04 - STRUCTURES
INDEX OF DRAWINGS

90% DESIGN REVIEW 03/09/2016

PROJECT TITLE:
RECONSTRUCTION OF ROUTE 349 NB AND SB OVER AMTRAK RAILROAD

STAGE 1 - REMOVAL OF SUPERSTRUCTURE

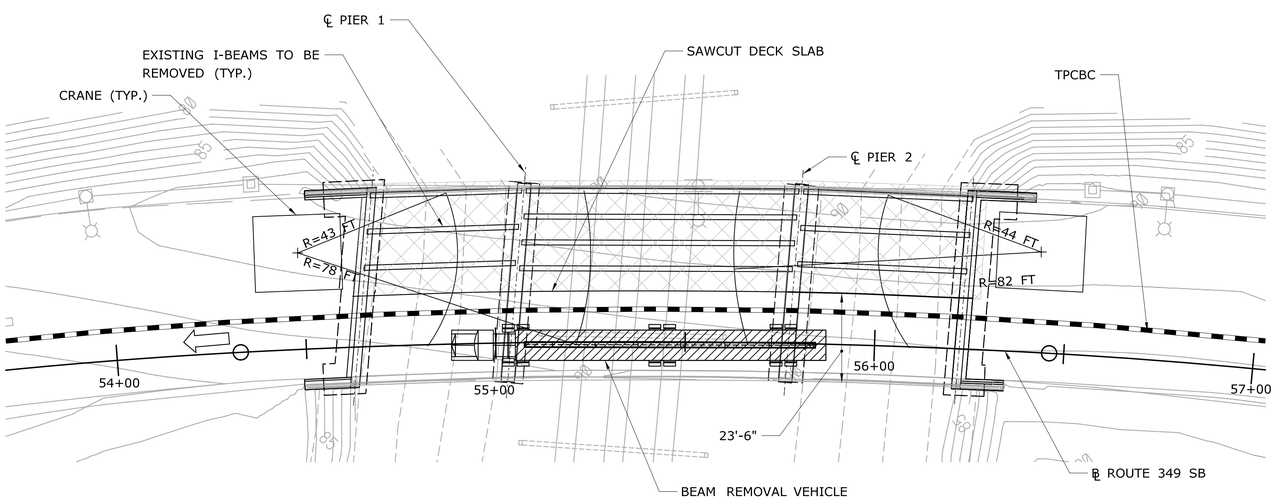
Stage Construction Notes 8 & 9: Plans need to show the railroad ROW. Foul times need to be determined and listed.

STAGE 1 - SUPERSTRUCTURE ERECTION

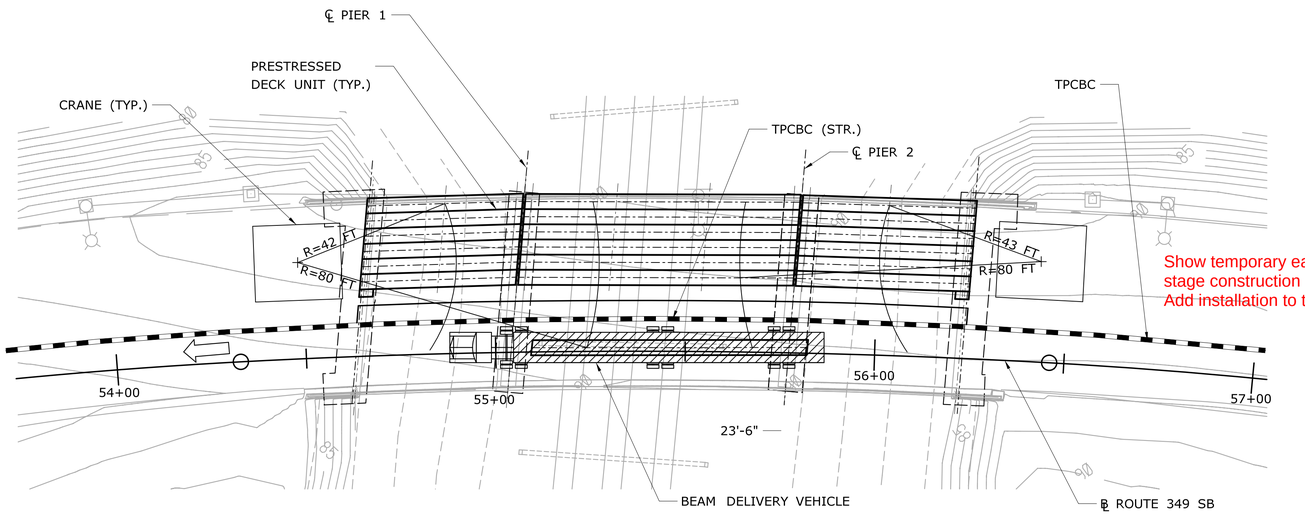
Show temporary earth retaining system on the stage construction plans (S-8, S-9, S10 & S-11). Add installation to the construction sequence.

SECTION A
SCALE: ½"=1'-0"

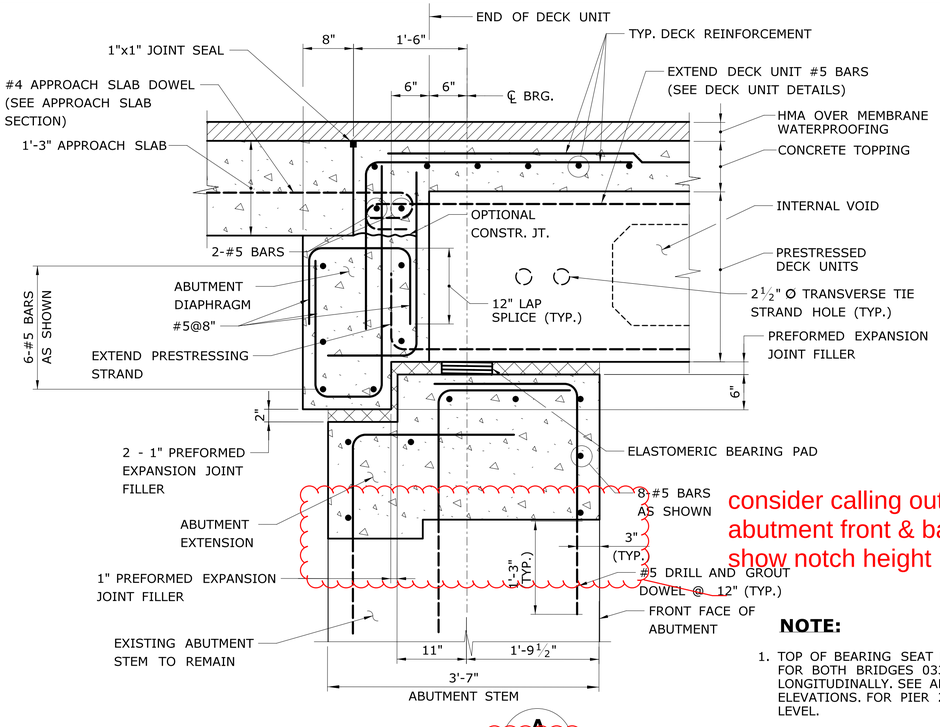
consider calling out sawcuts at abutment front & back faces; show notch height
